DEVIATION REQUEST AND DECISION FORM

Project Name : SF221: Skyline at Lorson Ranch Filing 1

A deviation from the standards of or in Section **El Paso County Standard Drawing of the Engineering Criteria Manual (ECM) Detail SD 4-20**, is requested.

Exhibit showing Chemical
Grout Locations on Skyline at
Lorson Ranch Filing 1

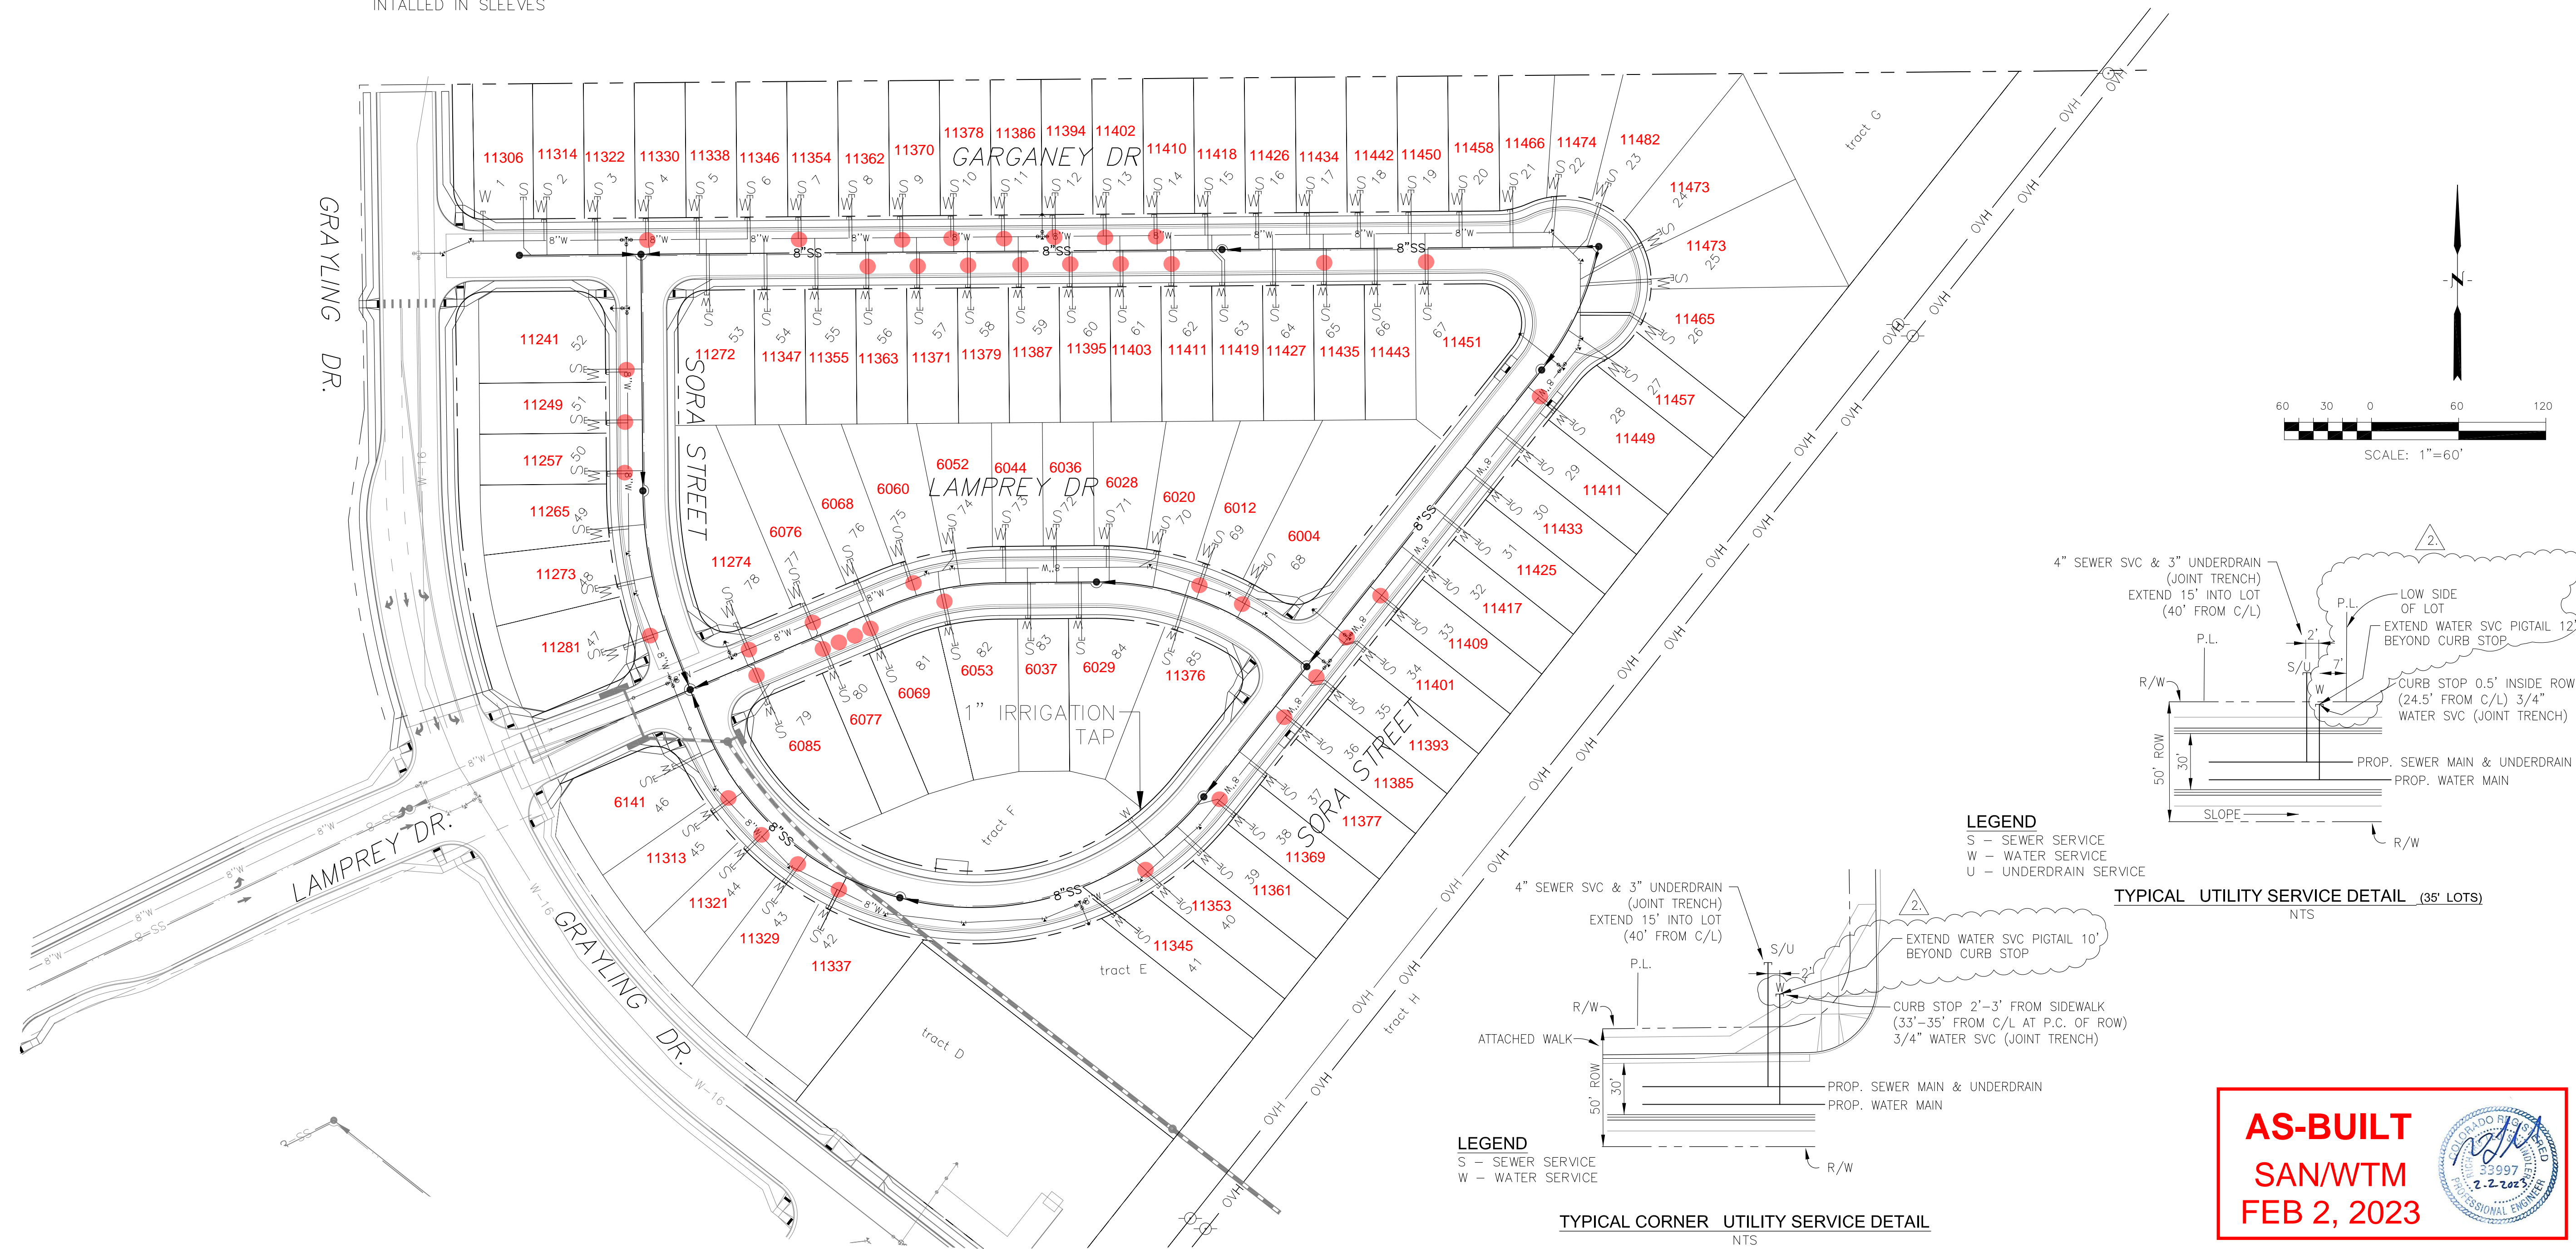
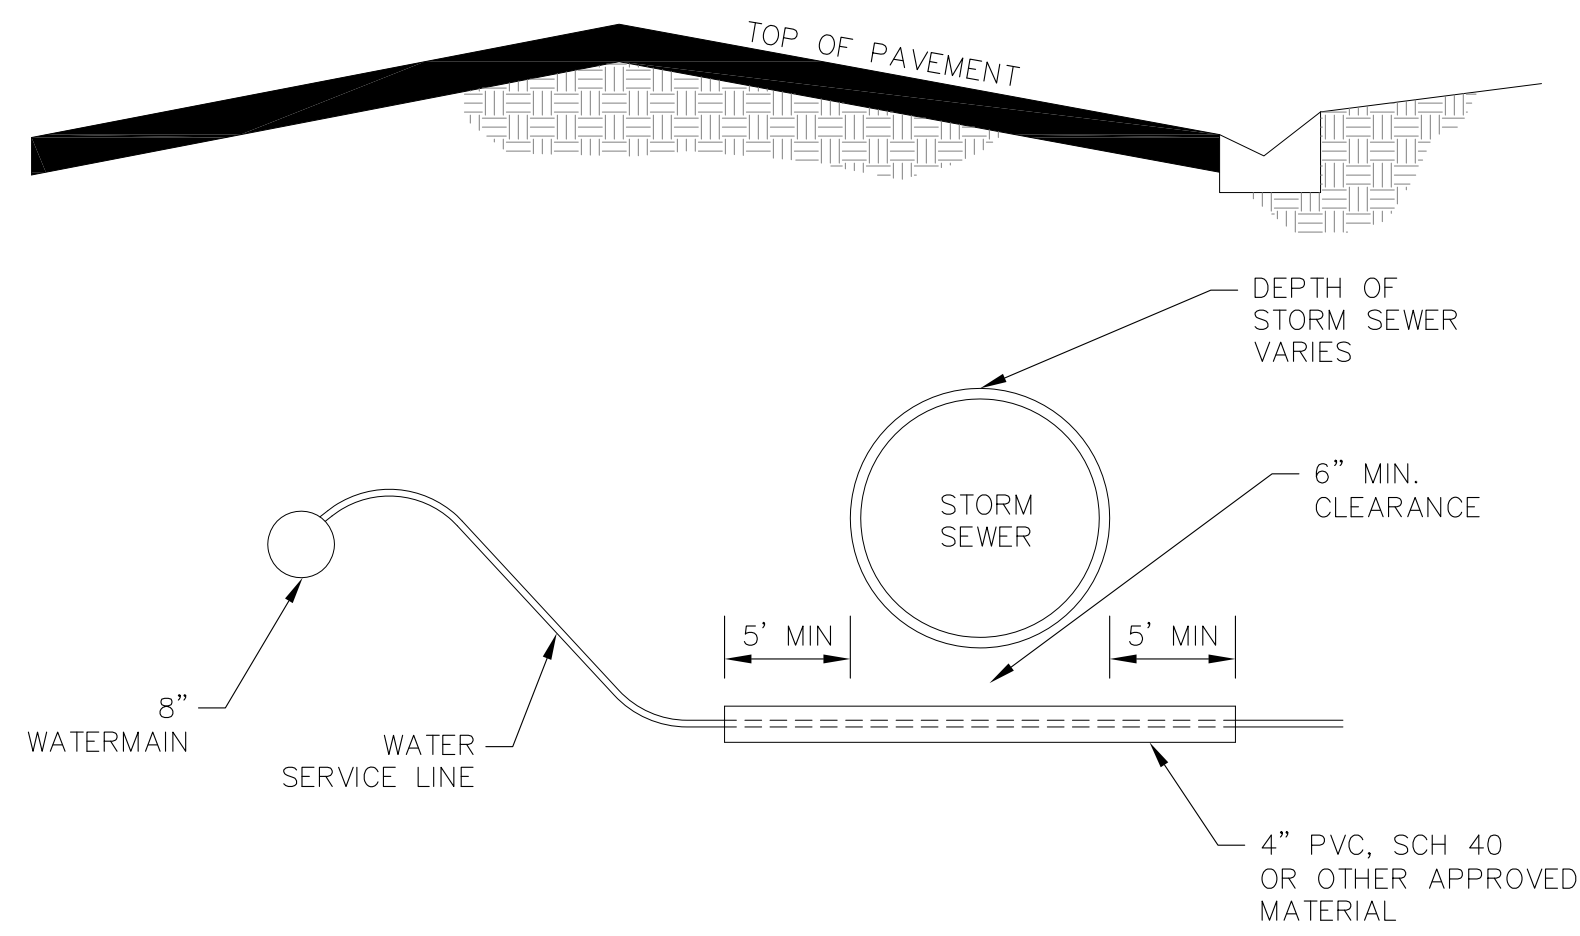
Deviation request for the use of the chemical grout to stabilize the soils within the roadway and utility trenches where settlement and distress were observed and to lift and relevel pavement, concrete flatwork, and stormwater catch basins. The deviation request is requested for Skyline at Lorson Ranch Filing 1 (File# SF221)

The chemical grout should initially be injected approximately 4 feet on center within the utility trenches through a 1/2" injection rod advanced to a depth no greater than 4 feet below land surface (bls) through 5/8" diameter drilled holes. After an initial stabilizing injection volume that will be determined on a case-by-case basis, the injection rod tip will be raised to approximately 1.5' to 2' bls or within 0' to 1' ft bls of the base of the cement-treated subgrade (CTS) to lift and relevel the concrete slabs or pavement. When being utilized to relevel installed stormwater vaults, concrete sidewalks, or concrete curbs, the material will be injected directly beneath the concrete. The elevations of the pavement/slabs should be monitored continuously during the chemical grouting

● Minimum 1/2" pavement deflection - area to be treated with chemical grout
